# Memorandum

Subject: INFORMATION: New Policy with respect to compliance with § 25.785(d), Amendment 25-88, for certification of passenger seat armrests.

<b>DISPOSITION OF PUBLIC COMMENTS ON DRAFT POLICY STATEMENT 02-115-15, COMPLIANCE WITH 25.785(D), AMENDMENT 25-88, CERTIFICATION OF PASSENGER SEAT ARMRESTS</b>	
Commenter	Comment	Disposition
GAMA	GAMA is concerned that all armrests meeting the definition of unbounded armrests would be required to be padded under the new policy.	The definitions do apply to all seats, however, only those armrests within the 35-inch head strike arcs need to be padded. A clarification to the policy will be made to address this issue.
GAMA	GAMA is concerned that the policy item numbers 1 and 2 are contradictory concerning the amount of acceptable offset.	The policy item number 1 is intended to address armrest offset 0 to .5 inches and item number 2 is intended to address bounded armrest and non-exposed unbounded armrest offset between .5 and 2.0 inches. A clarification to the policy will be made to address this issue.

Figure 1

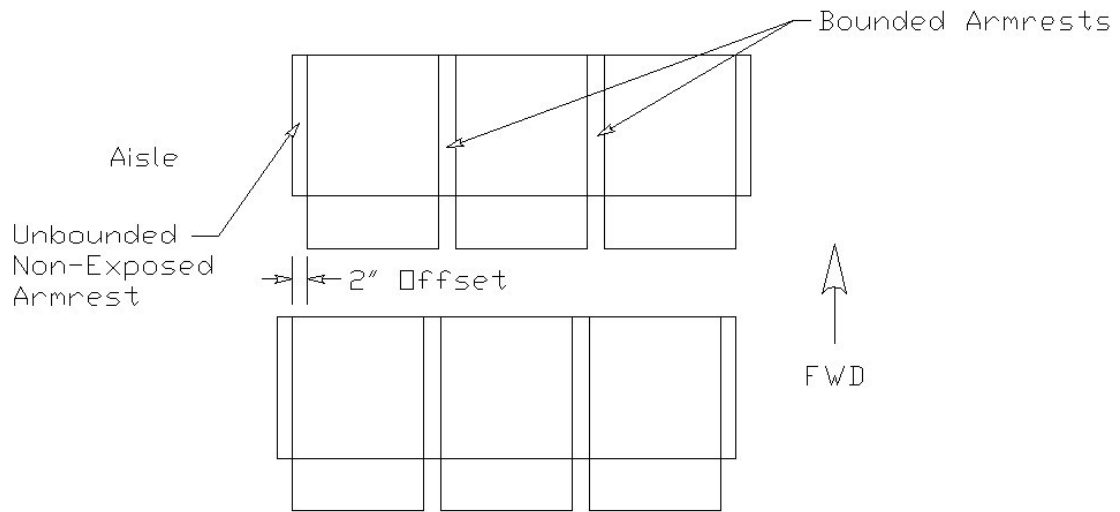
Unbounded armrests are those that do not meet either definition above. Additionally, seat places that are located aft of unbounded armrests may be characterized as either “exposed” or “non-exposed.” The non-exposed seat place is typically an aisle seat place, i.e., located adjacent to a passenger aisle (see Figure 1). The exposed seat place is typically located where the number of seats in the row forward is different from that of the seat row aft. For example, near Type III overwing exits, many airplanes have a double seat installed inboard of the exit with an empty space between the seat and the exit. The seat row aft of the double seat has a triple seat (see Figure 2). In Figure 2, seat place “A” is an exposed seat place that makes the outboard armrest of the double seat an unbounded exposed armrest.
